Pontiac, Boston, Nokomis, and Rosewood Reconstruction

Exhibit A - Accessibility Must Be Meaningful

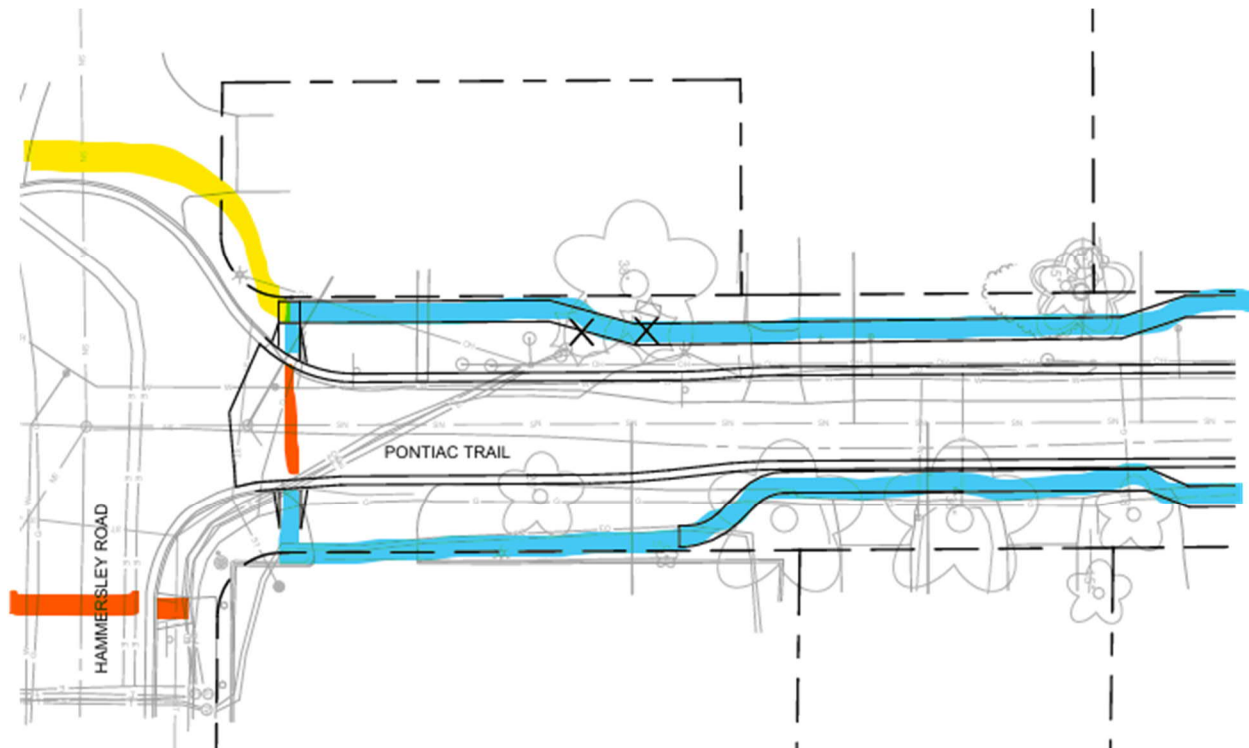
The current sidewalk design on Pontiac Trail requires pedestrians to cross the street twice to reach the Southwest Bike Path. This raises a critical question: Why is the sidewalk not directly connected to the multiuse path via the yellow connection?

Red Highlights: The current design requires two street crossings to travel from the Southwest Path to Zook Park. An unnecessary burden for residents with mobility or vision challenges.

Does the current design deliver on that consistency and predictability? Please discuss.

Exhibit B - Overbuilt Design Contradicts Green Streets Principles

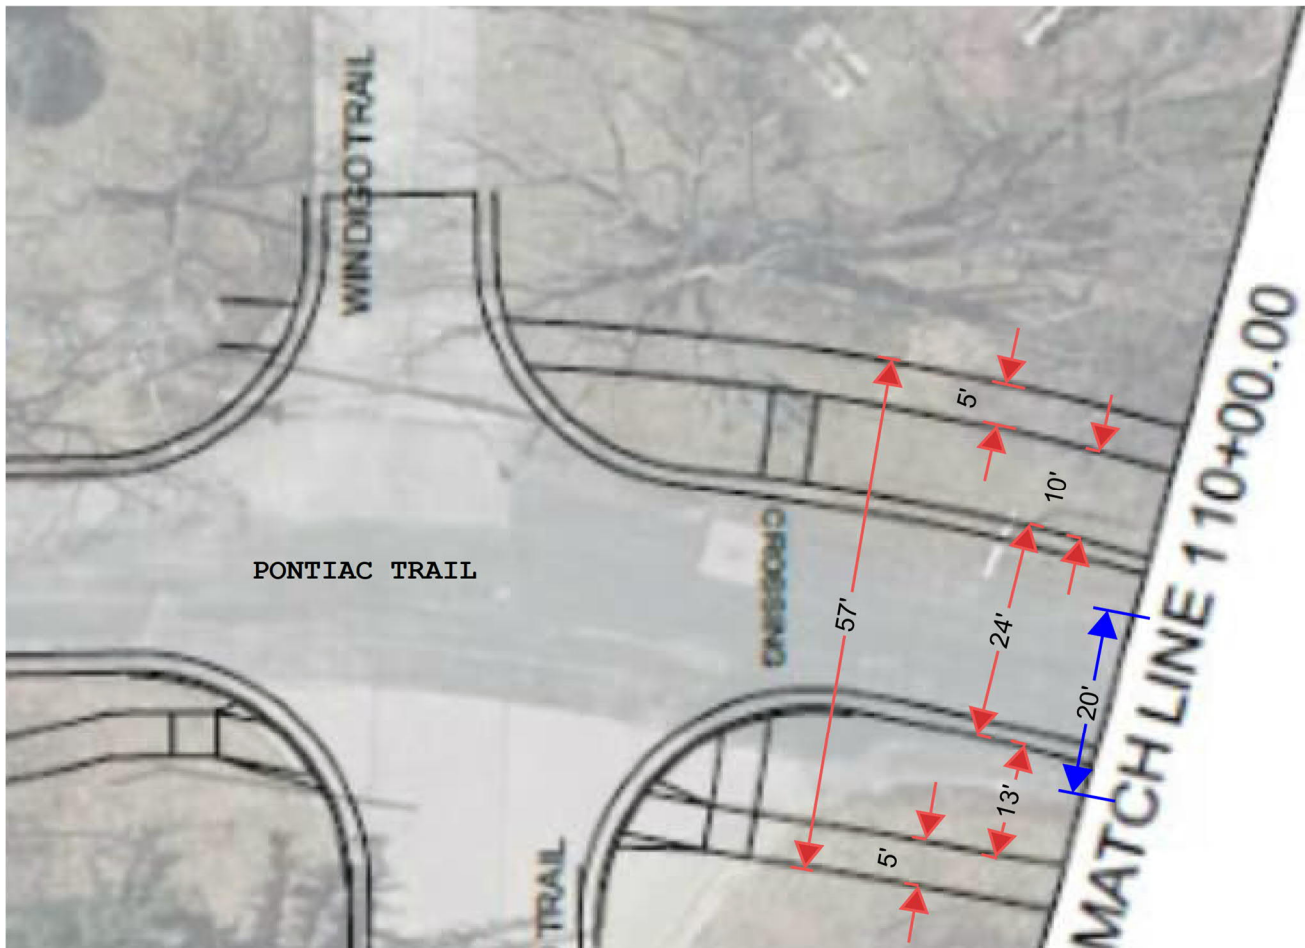
The new design is almost 3x wider than the current street.

- ***Is this design truly responsive to neighborhood scale and character?***
- ***Does it reflect the Guide’s call for restraint, balance, and environmental sensitivity?***
- ***Must we use the full right-of-way simply because it exists?***

Questionnaire Results

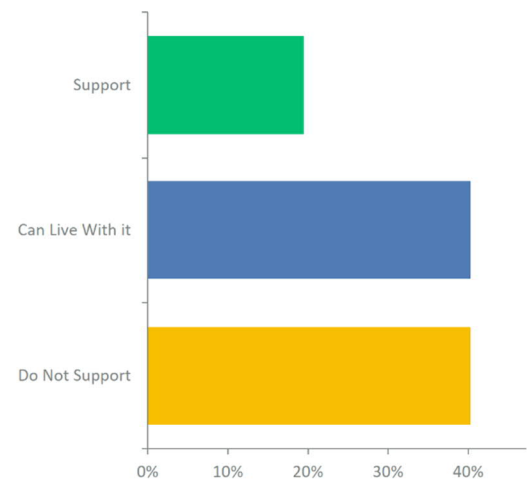
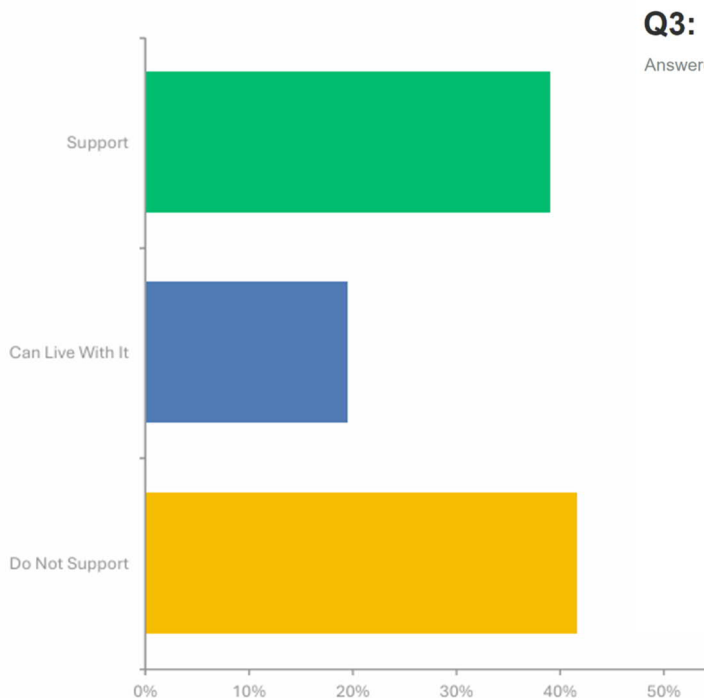
The public was presented with two design options. Even members of the Commission struggled to distinguish between them. Many residents I spoke with felt compelled to choose one — unaware that “neither” was a valid response.

Less than 40% support the project. Without genuine buy-in, this project risks falling short of its potential.

I urge the Commission to conduct a new survey focused solely on Option 1 — to accurately gauge current neighborhood support.
